VIRGINIA ELECTRIC AND POWER COMPANY
SURRY POWER STATION UNITS 1 AND 2
ASME SECTION XI RELIEF REQUEST
NOTICE OF CHANGE TO TEMPORARY REPAIR AND
EXTENDED USE OF A TEMPORARY NON-CODE PIPE REPAIR

Notice of Change to Temporary Repair and
Request for Extended Use of Temporary Repair on "D" Component Cooling Heat
Exchanger Service Water Discharge Piping

System: Service Water
Class: ASME Class 3
Drawing: 11448-FM-071A Sh. 4
Component: 30"-WS-41-10

COMPOSITE SAFETY RELATED PIPING
 TURBINE BUILDING
 SURRY POWER STATION - UNIT 1

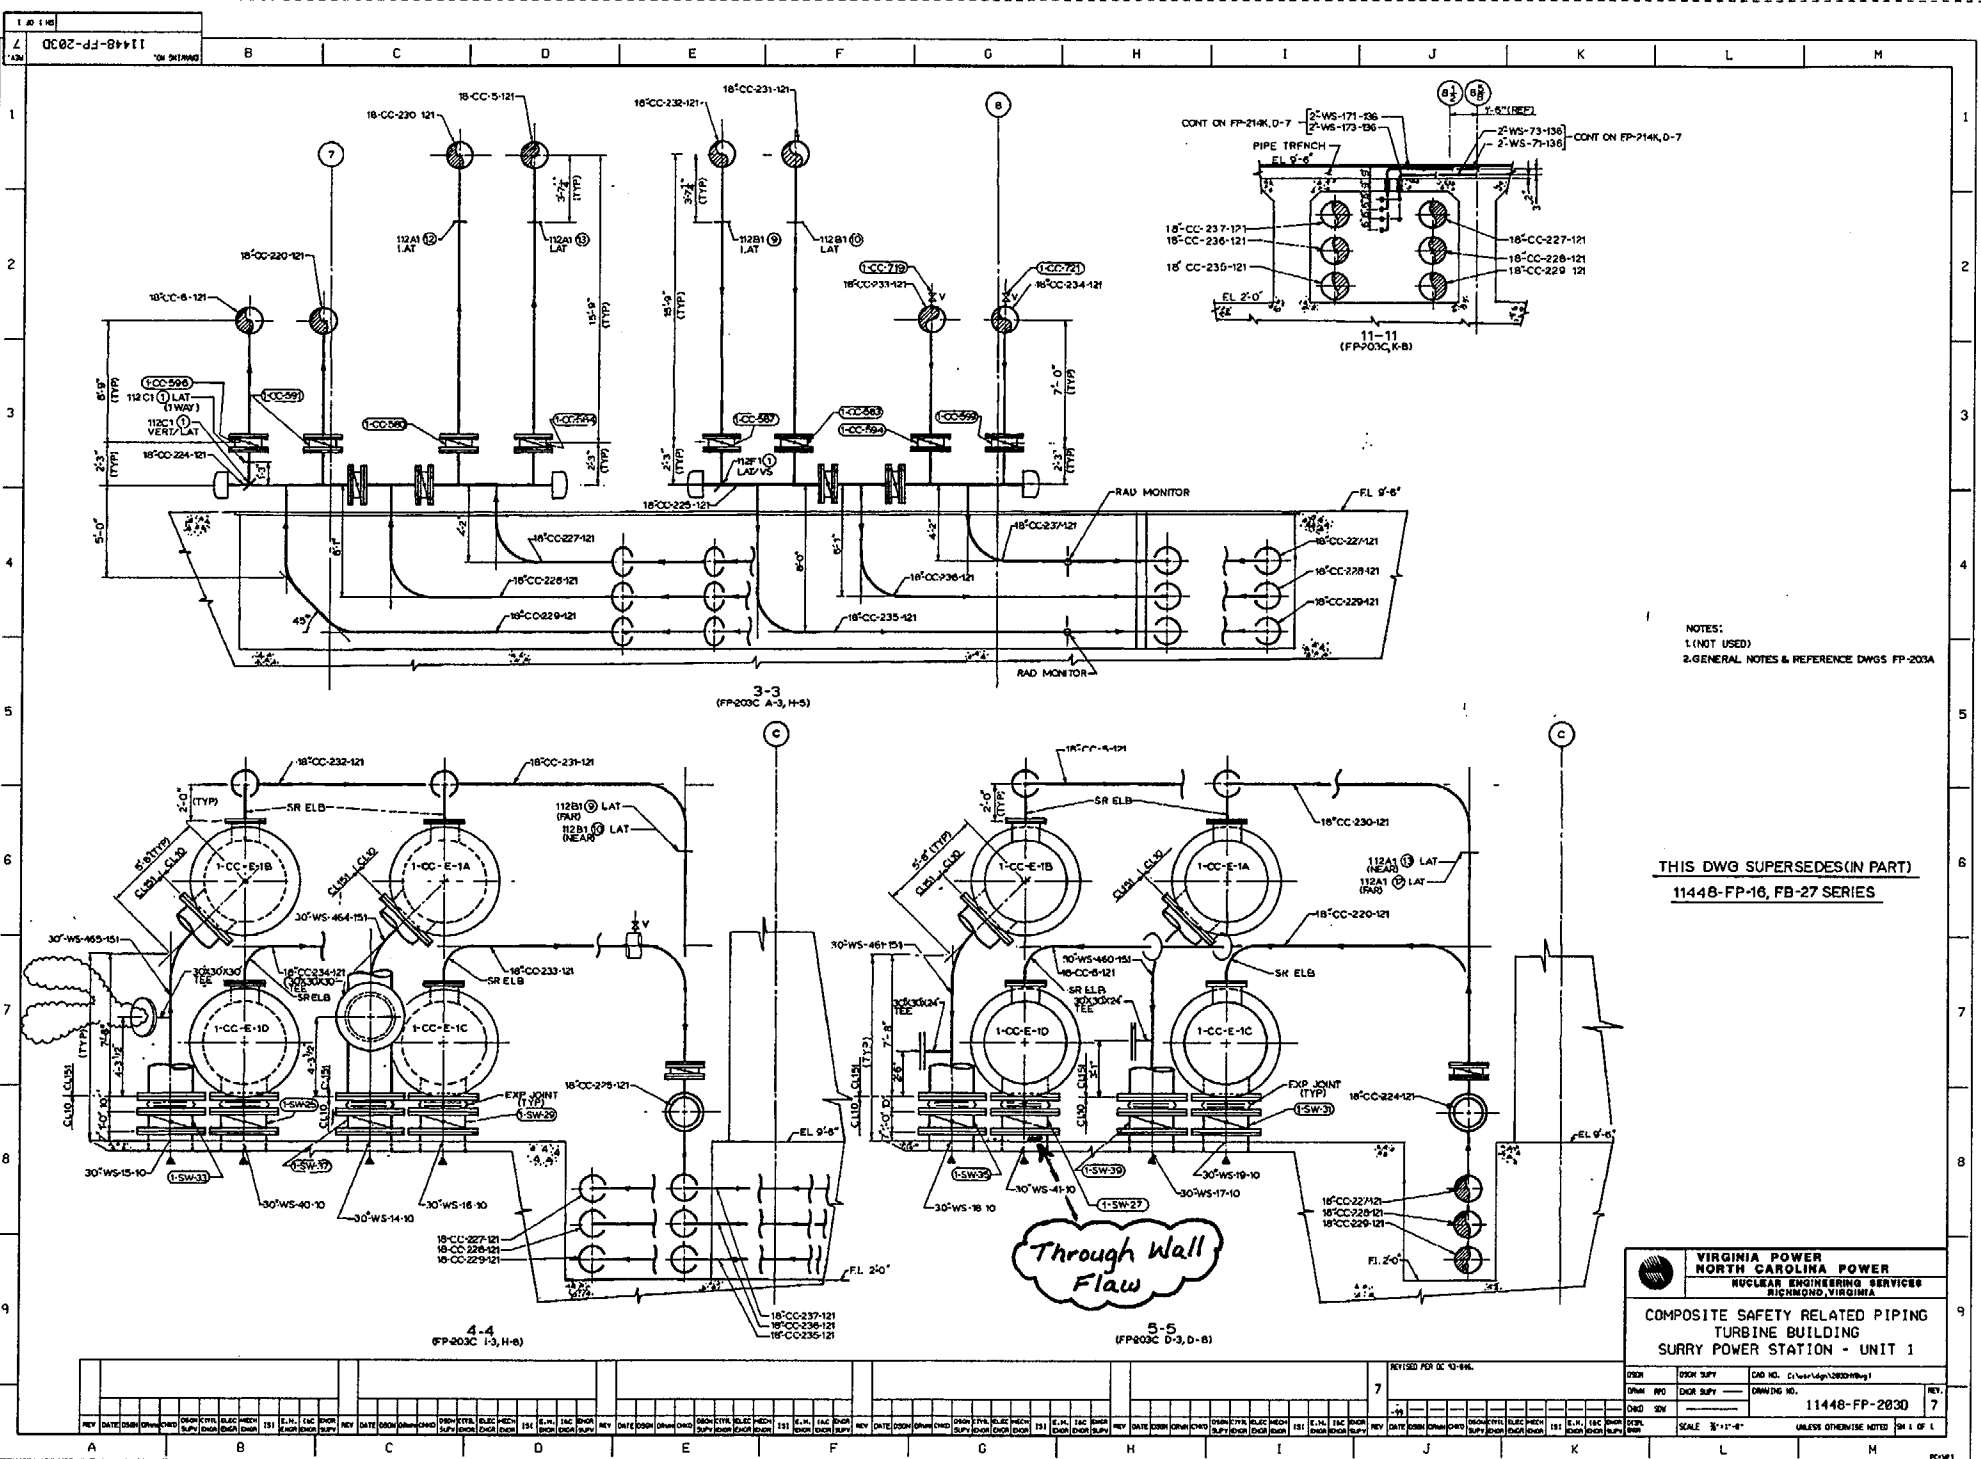
A through wall leak exists on the moderate energy service water (SW) system downstream of the "D" CCHX (1-CC-E-1D) discharge isolation valve 1-SW-27. (See attached drawing 11448-FP-203D.) The flaw was evaluated by the "through wall" flaw method and determined to be within Generic Letter 90-05 guidelines. Virginia Electric and Power Company (Virginia Power) previously submitted a relief request dated October 20, 1999 (Serial No. 99-495) that requested the use of a temporary non-Code repair in accordance with Generic Letter 90-05. A temporary patch comprised of rubber gasket material and a 1/8 inch thick steel backing plate was placed over the hole and is held in place with stainless steel bands.

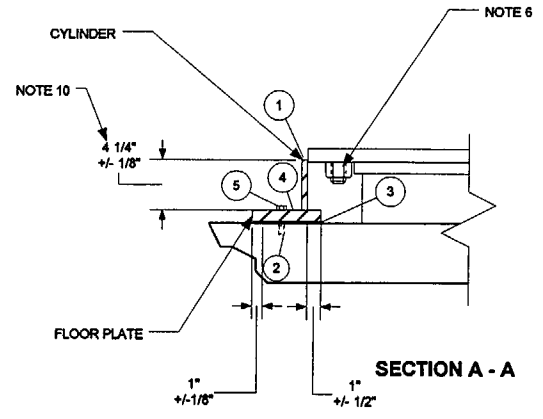
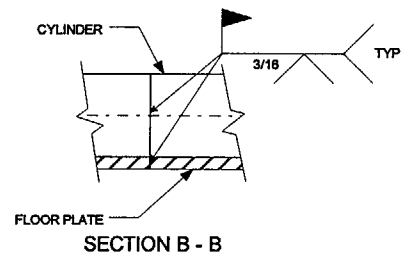
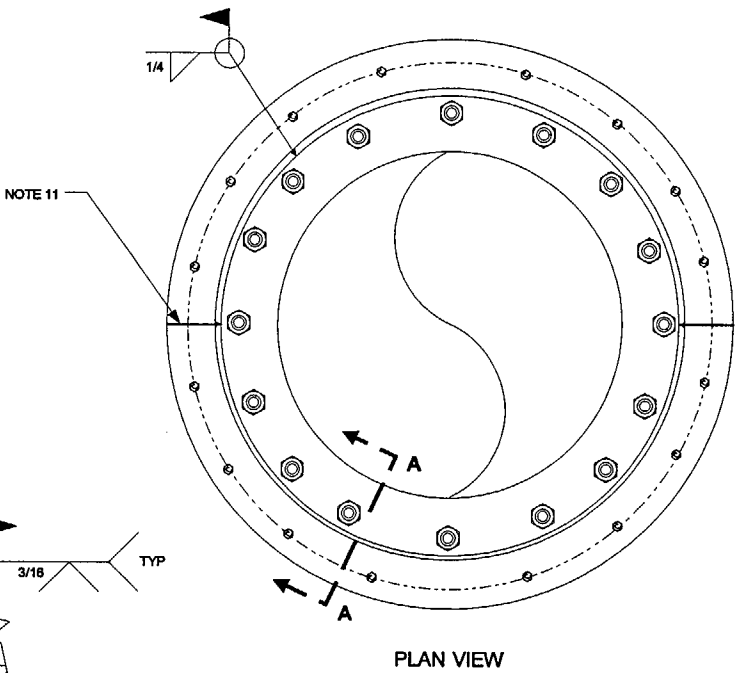
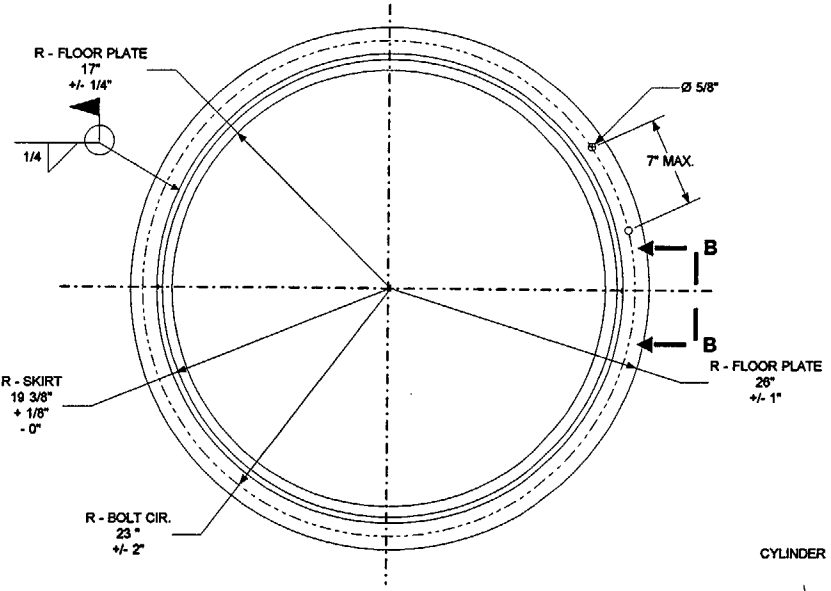
A more substantial non-Code repair has been designed and evaluated and will be installed before the Unit 1 Spring 2000 outage. This repair will provide a 1/2 inch thick, ASTM A36 steel cylindrical enclosure from the concrete floor to the flange above the flaw. The top of the cylinder will be welded to the rim of the flange and the bottom of the cylinder will be welded to a 1" thick steel plate that is anchored to the floor with sixteen 1/2 inch diameter bolts. The existing soft patch will remain in place and be completely enclosed, as well as the entire pipe segment containing the flaw. Both the carbon steel cylinder and floor plate will be internally coated for corrosion prevention. The attached drawings (ET S-990236-1-M-800, Sheets 1 and 2) provide details of the repair.

The enclosure has been evaluated for design and seismic loading conditions by engineering and confirmed to be acceptable for the intended use. The engineering evaluation has also concluded that no safety related equipment would be rendered inoperable as a result of leakage at the repair location. Furthermore, the existing IPE Flooding Analysis has been determined to bound the flooding effects from a postulated rupture of the subject pipe.

Periodic inspections to confirm structural integrity and leak tightness of the more substantial repair will be performed as follows: 1) weekly visual VT-2 inspections for leakage and 2) quarterly VT-1 weld and VT-3 structural inspections. The history of corrosion rates on carbon steel in similar applications at Surry Power Station show the wall thickness of the cylinder would not be subject to significant loss during the proposed service life. UT thickness readings of the exposed cylinder would not provide information needed to monitor the structural integrity of the cylinder.
